Customer Name:		Gallien-Krueger		Current Rev #:		A1		New ECO Rev #:		A2	
Model:		Backline 250, 600, 115 Combo,		Distribute To:				Page:		1 Of: 2	
Assembly Description:		and 210 Combo		Originator:		Enrique Hernandez					
Assembly Numbers:		206-0181-A		Approved by:				Effective Date:		2/15/2005	
Effective				Document Update				Date		Initials	
<input checked="" type="checkbox"/>	All in Process	<input checked="" type="checkbox"/>	Next Buy	<input type="checkbox"/>	Artwork						
<input type="checkbox"/>	All in Service	<input checked="" type="checkbox"/>	Next Production Run	<input type="checkbox"/>	Assembly Dwg.						
<input checked="" type="checkbox"/>	All in Stock	<input type="checkbox"/>		<input type="checkbox"/>	Board Artwork						
Beginning Serial Number:				<input checked="" type="checkbox"/>	BOM						Noli
Reason For Change				<input type="checkbox"/>	Control Form						
Pre-Amp revoiced to sound more like the 400RB-IV.				<input checked="" type="checkbox"/>	Costing						TC

TITLE: BACKLINE 115 PREAMP  
REV: A2

404-0181-A3

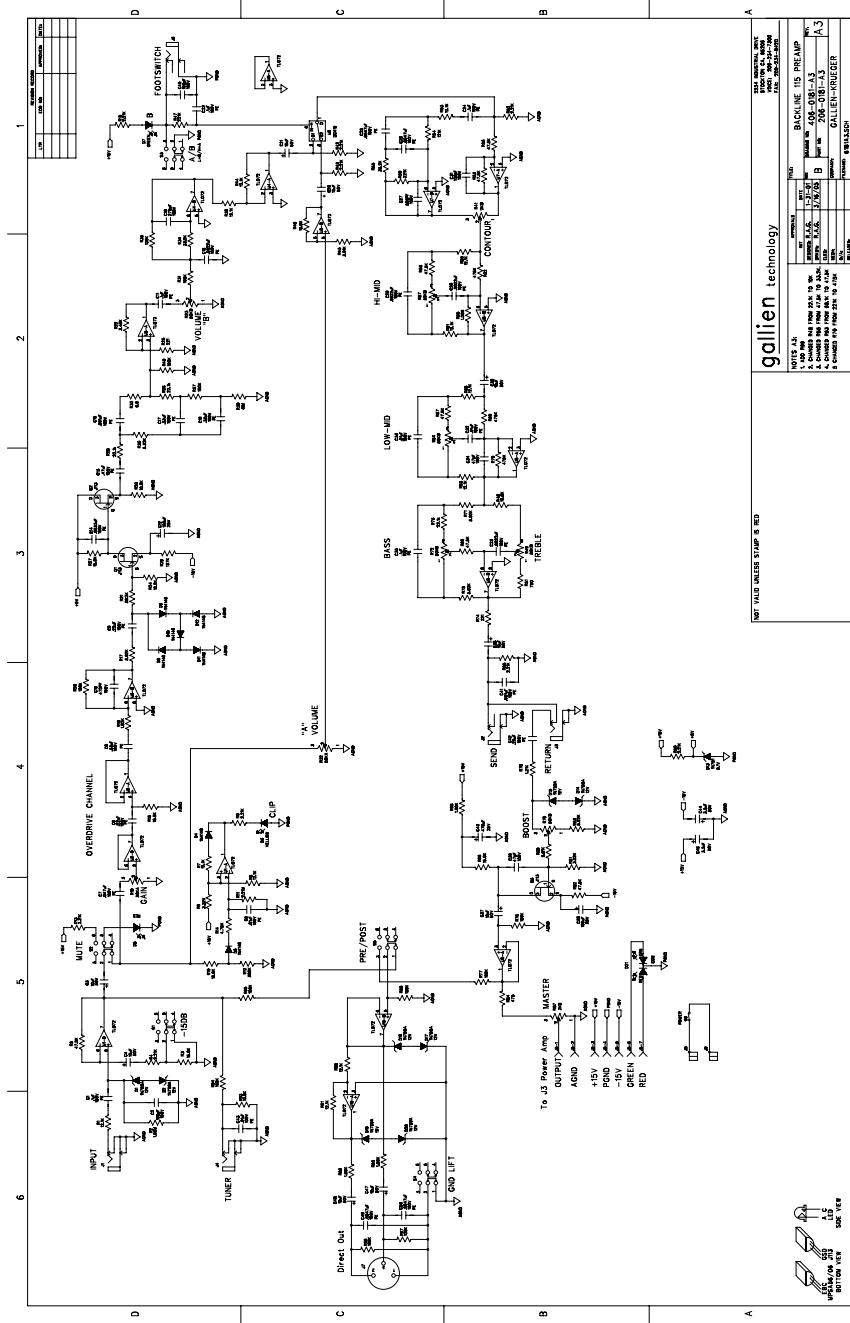
1. Changed resistor R48 from 5.62K to 22.1K  
2. Changed resistor R51 from 5.62K to 22.1K  
3. Changed resistor R53 from 47.5K to 88.1K  
4. Changed resistor R55 from 47.5K to 22.1K  
5. Changed resistor R57 from 47.5K to 22.1K  
6. Changed resistor R59 from 47.5K to 22.1K

TITLE: BACKLINE 115 PREAMP  
REV: 1-01  
DATE: 3/18/03  
DRAWN: R.A.G.  
ELEC: B  
PART NO: 206-0181-A4  
COMPANY: GALLIEN-KRUEGER  
RELEASED: 2/1/03

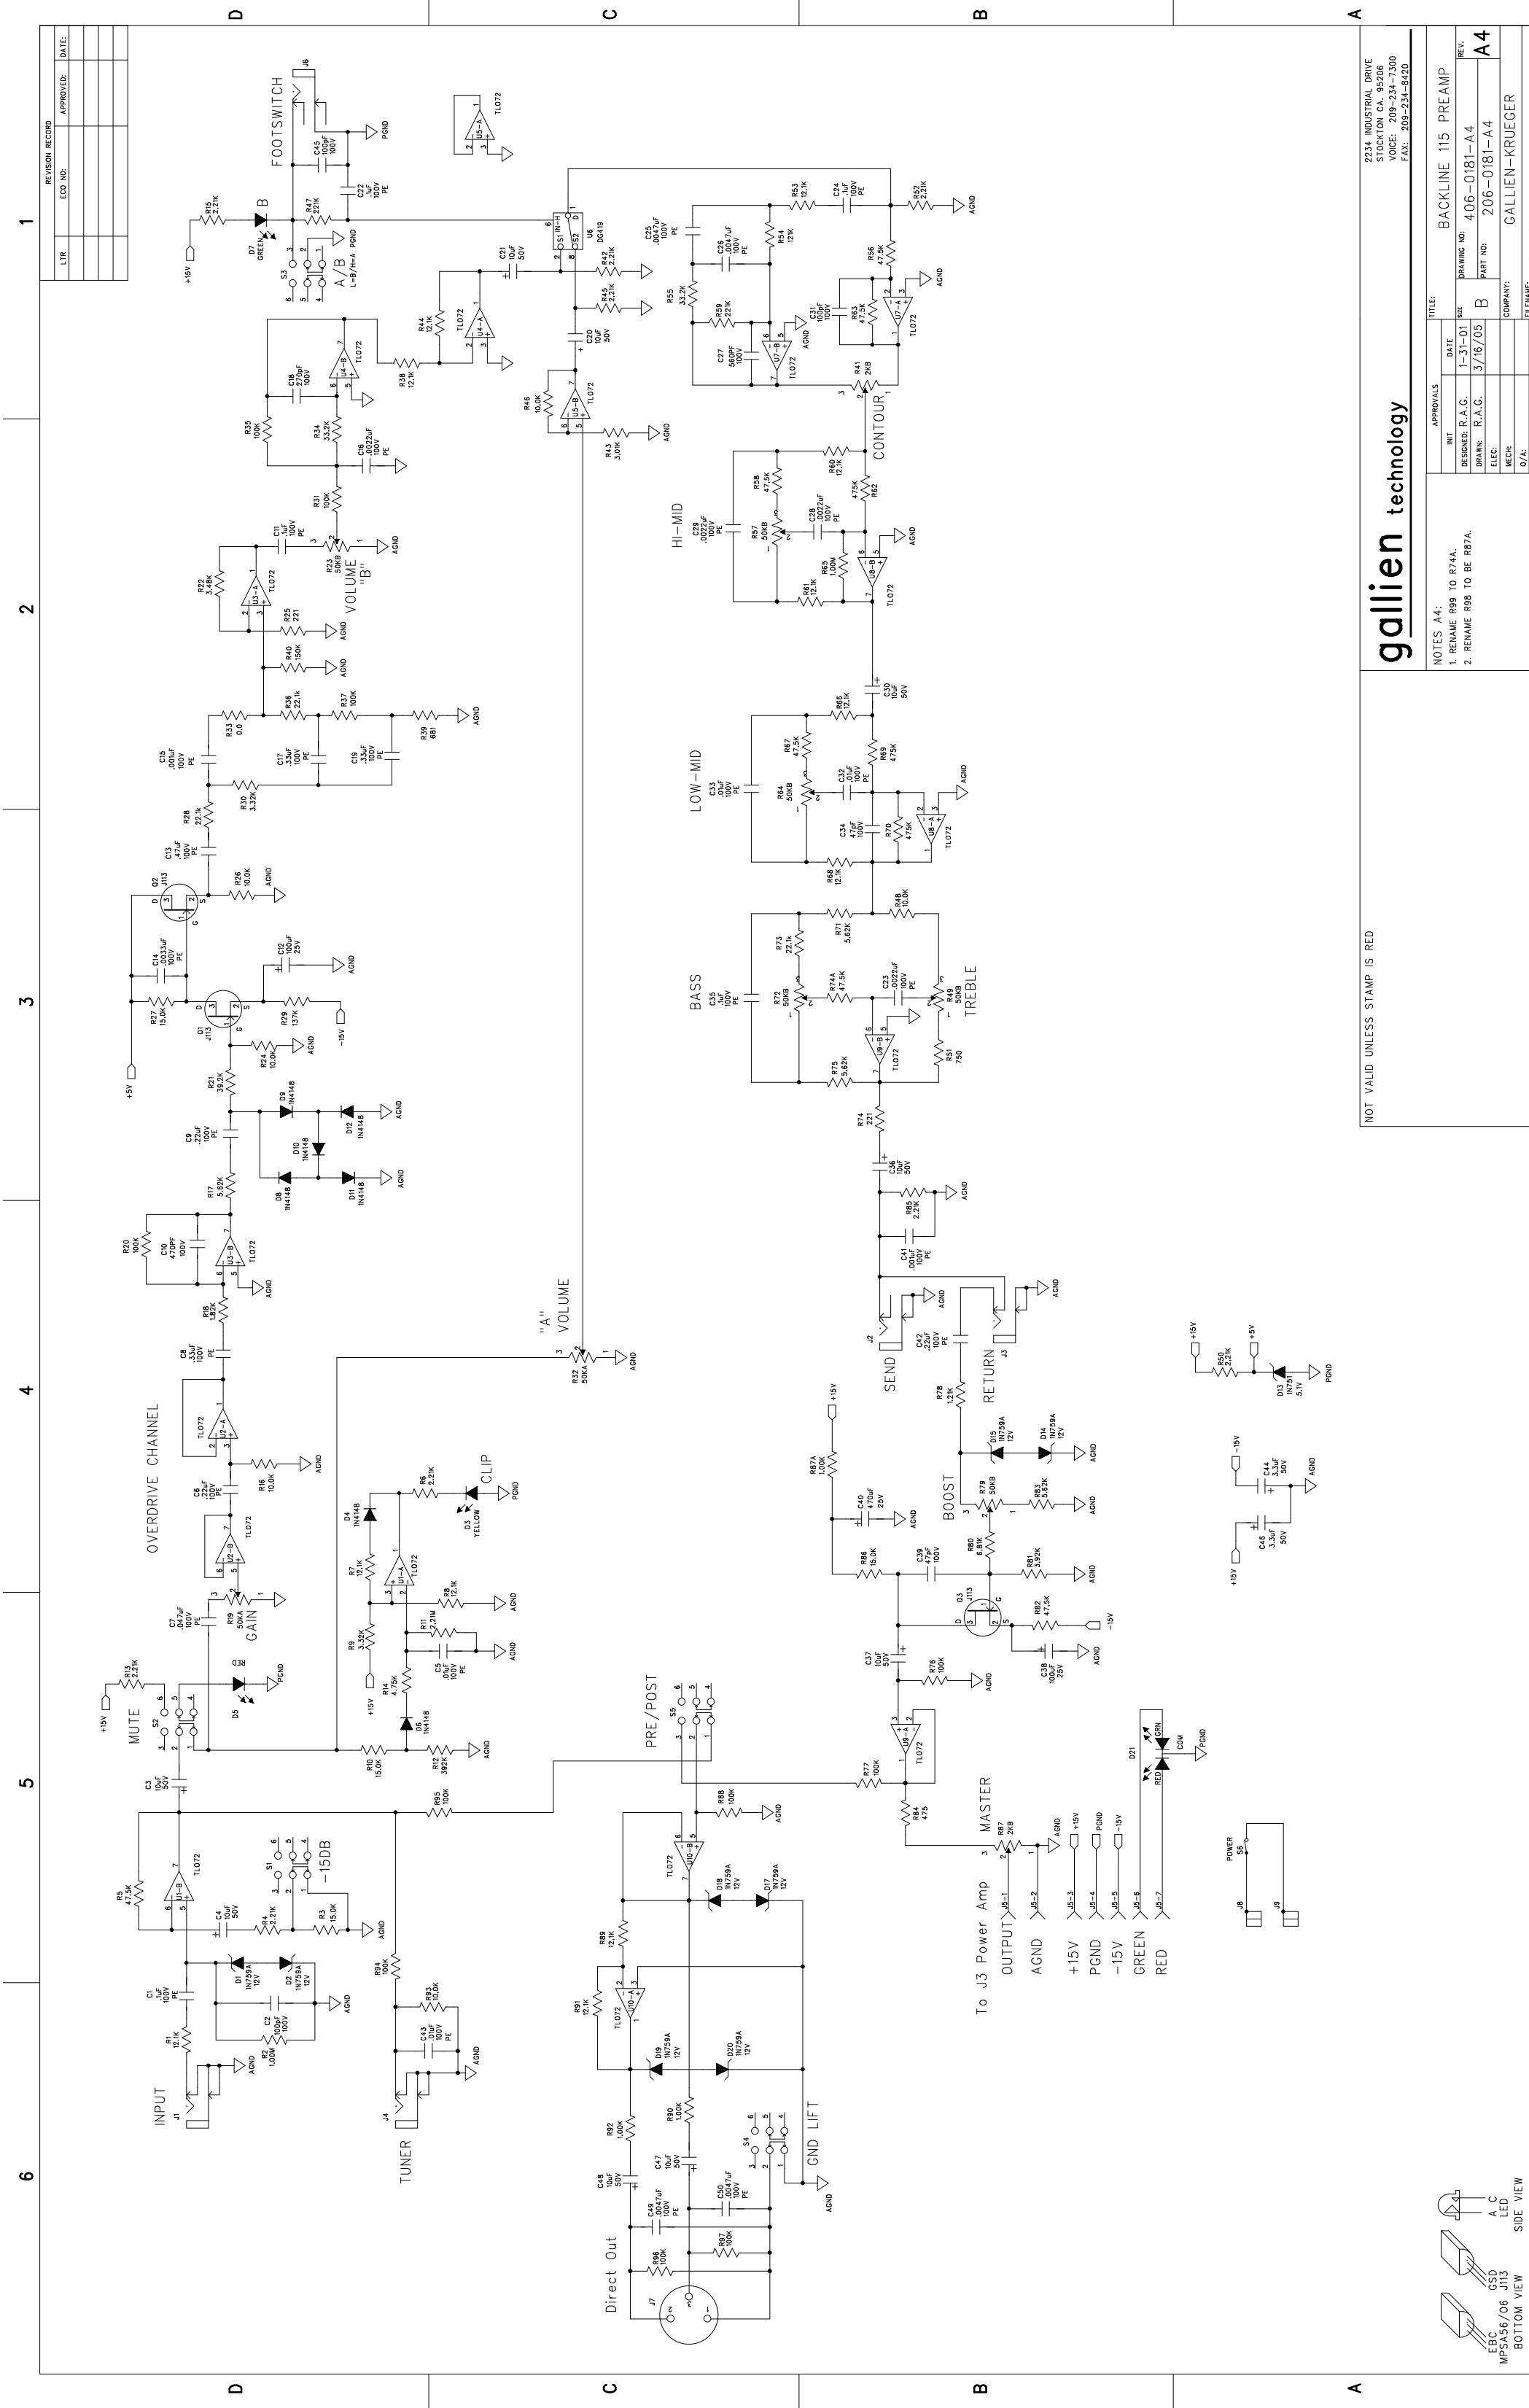
Customer Name:		Gallien-Krueger		Current Rev #:		A3		New ECO Rev #:		A4	
Model:		Backline 250, 600, 115 Combo,		Distribute To:				Page:		1 Of: 2	
Assembly Description:		and 210 Combo		Originator:		Enrique Hernandez					
Assembly Numbers:		206-0181-A		Approved by:							
				Effective Date:		3/17/2005					
Effective				Document Update				Date		Initials	
<input type="checkbox"/>	All in Process	<input checked="" type="checkbox"/>	Next Buy	<input checked="" type="checkbox"/>	Artwork						RAG
<input type="checkbox"/>	All in Service	<input type="checkbox"/>	Next Production Run	<input type="checkbox"/>	Assembly Dwg.						
<input type="checkbox"/>	All in Stock	<input type="checkbox"/>		<input type="checkbox"/>	Board Artwork						
Beginning Serial Number:				<input checked="" type="checkbox"/>	BOM						Noli
Reason For Change				<input type="checkbox"/>	Control Form						
Renaming of two resistors on the pre-amp board to match layout counting scheme of the board.				<input checked="" type="checkbox"/>	Costing						TC

<input type="checkbox"/>	Fab Drawing						
				<input type="checkbox"/>	Inspection Proc.						
				<input checked="" type="checkbox"/>	Part Master File						Noli
				<input checked="" type="checkbox"/>	Schematic						RAG
				<input type="checkbox"/>	Service Manual						
				<input type="checkbox"/>	Test Procedure						
				<input type="checkbox"/>							
				<input type="checkbox"/>							
				Other Affected Assemblies							
				209-0180-A, 303-0180-A,							
				303-1180-A, 303-2180-A							
<input type="checkbox"/>	Continued on ECO Supplement Page										
Description Of Change				Distribution				Date		Initials	
Update BOM.				<input type="checkbox"/>	Accounting						
Update Part Master File.				<input type="checkbox"/>	Assembly						
Updated Artwork 145-0181-A4.				<input checked="" type="checkbox"/>	Customer						
Resistor R98 changed to R87A, and resistor R99 changed to R74A.				<input checked="" type="checkbox"/>	Engineering

NOTES A4:  
1. RENAME R98 TO R74A.  
2. RENAME R98 TO BE R74A.

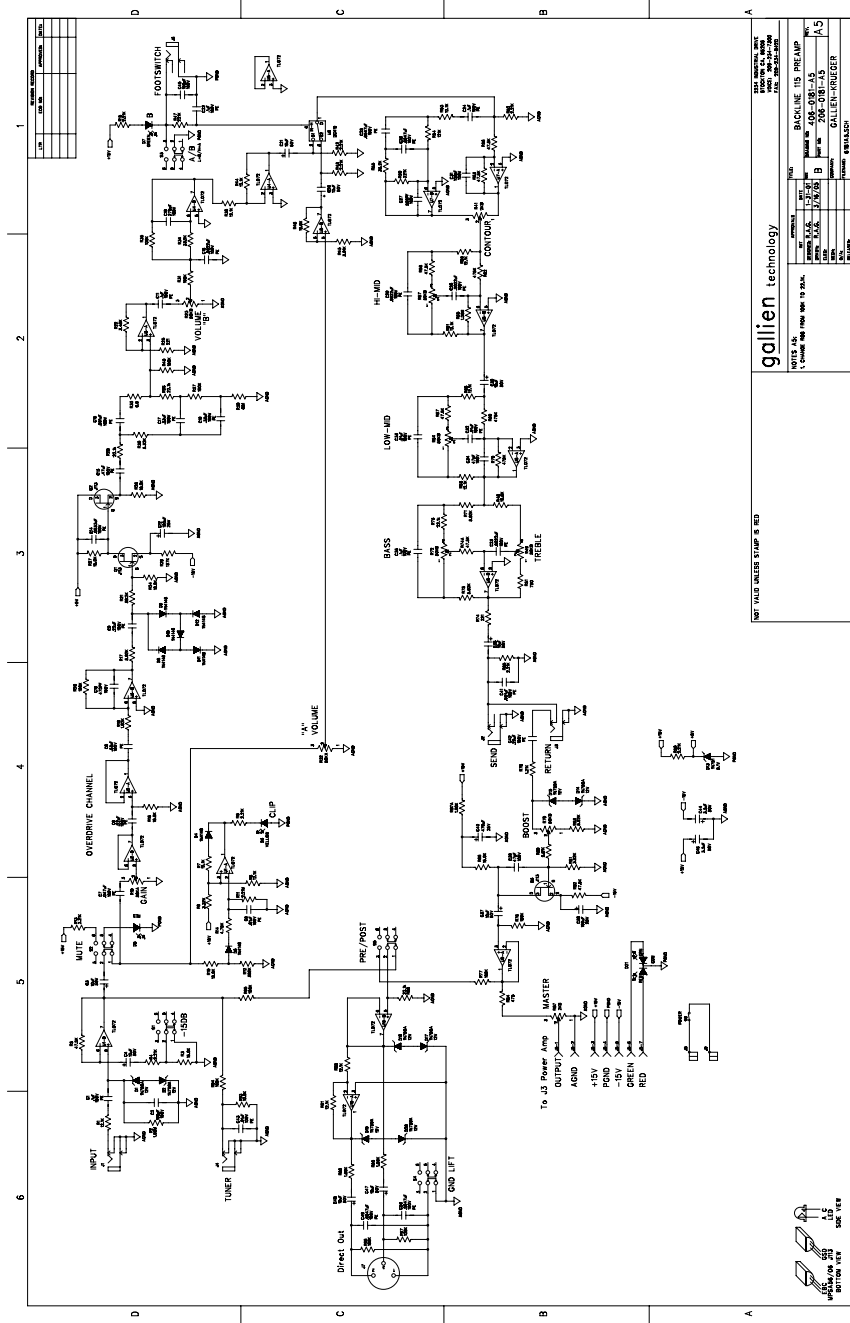
Customer Name:		Gallien-Krueger		Current Rev #:		A4		New ECO Rev #:		A5	
Model:		Backline 250, 600, 115 Combo, and 210 Combo		Distribute To:				Page:		1 Of: 2	
Assembly Description:		preamp board		Originator:		Enrique Hernandez					
Assembly Numbers:		206-0181-A		Approved by:							
				Effective Date:		12/15/2005					
Effective				Document Update				Date		Initials	
<input checked="" type="checkbox"/>	All in Process	<input checked="" type="checkbox"/>	Next Buy	<input type="checkbox"/>	Artwork						
<input checked="" type="checkbox"/>	All in Service	<input checked="" type="checkbox"/>	Next Production Run	<input type="checkbox"/>	Assembly Dwg.						
<input type="checkbox"/>	All in Stock	<input type="checkbox"/>		<input type="checkbox"/>	Board Artwork						
Beginning Serial Number:				<input checked="" type="checkbox"/>	BOM						Noli
Reason For Change				<input type="checkbox"/>	Control Form						
DI output too hot, need to decrease DI level to match the level of the 700RB-II/1001RB-II pre-amp when level knob is set to max.				<input checked="" type="checkbox"/>	Costing						TC

NOTES:  
 1. Check the spec for 100k.

BACKLINE 115 PREAMP  
DRAWING NO: 406-0181-A6  
REV: A6

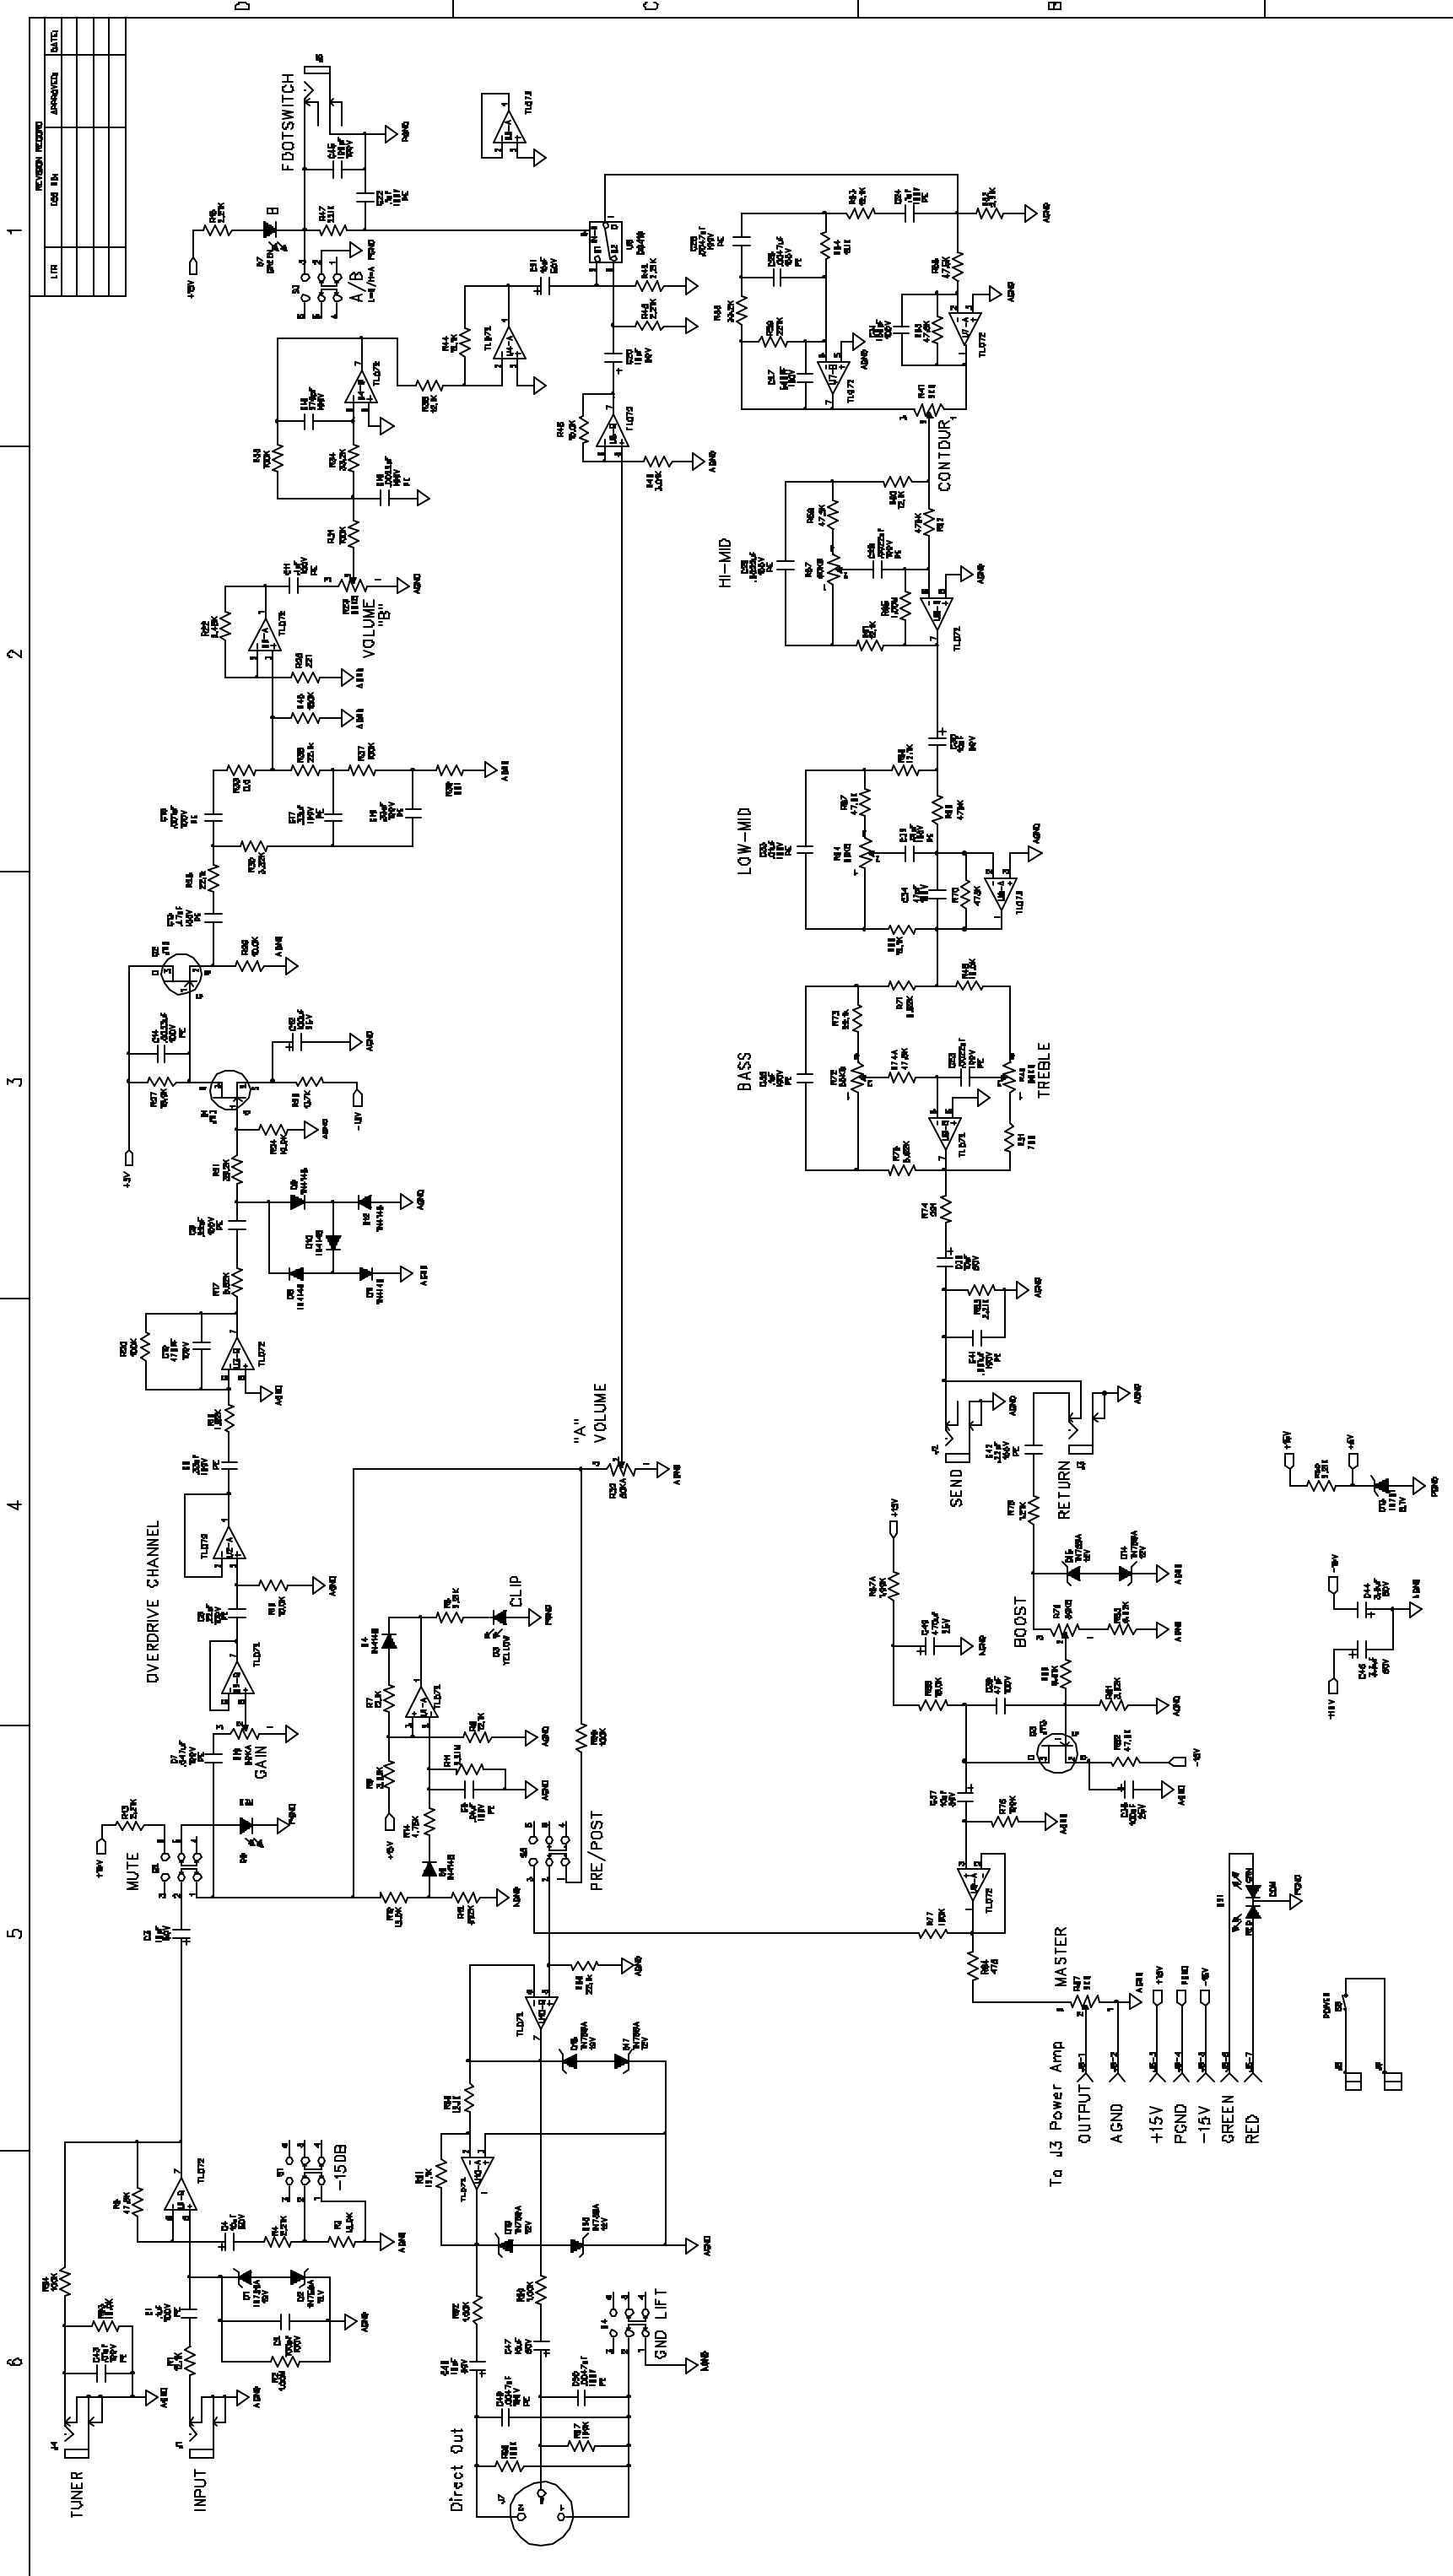
NOTES A6:  
1. MOVE R80 TO TOP OF R32.
